UNITED STATES
DEPARTMENT OF THE INTERIOR
BUREAU OF LAND MANAGEMENTFORM APPROVED
OMB NO. 1004-0135
Expires: July 31, 2010**SUNDRY NOTICES AND REPORTS ON WELLS**
*Do not use this form for proposals to drill or to re-enter an abandoned well. Use form 3160-3 (APD) for such proposals.*5. Lease Serial No.
NMLC029426B

SUBMIT IN TRIPLICATE - Other instructions on reverse side.8. Well Name and No.
CROW FEDERAL COM ~~288~~ 148 H9. API Well No.
30-015-43409-00-X110. Field and Pool, or Exploratory
FREN
Cedar Lake, Glenwater, Yesso11. County or Parish, and State
EDDY COUNTY, NM

Apache request change in Surface Use Plan - Proposed production facilities:

SURVEY FOR A PIPELINE TO THE CROW FEDERAL COM
#46H THRU #48H CROSSING SECTION 10,
TOWNSHIP 17 SOUTH, RANGE 31 EAST, N.M.P.M.
EDDY COUNTY, NEW MEXICO

EXHIBIT 1A

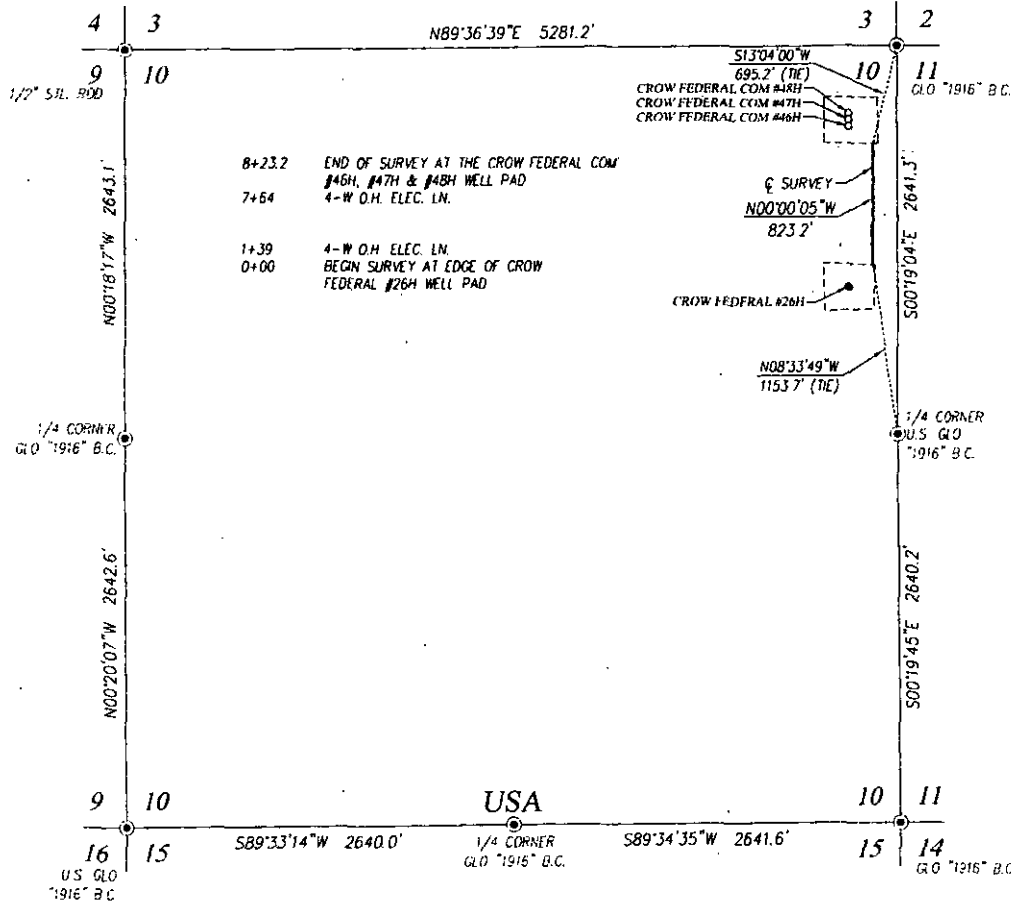
OLD: 4" buried Polyethylene, 740psi, 823' pipeline from proposed well to offsite facility at the Crow Federal Pad 27E Satellite. 30' work area needed to install pipeline.

NEW: 3" buried, 3.53 OD, 2.96 ID, 750psi Fiberspar flowline approx 823' in length to the Crow Federal Pad 27E Satellite following same path as on approved APD (Exhibit 1A attached). A 50' wide work area will be needed to install pipeline.
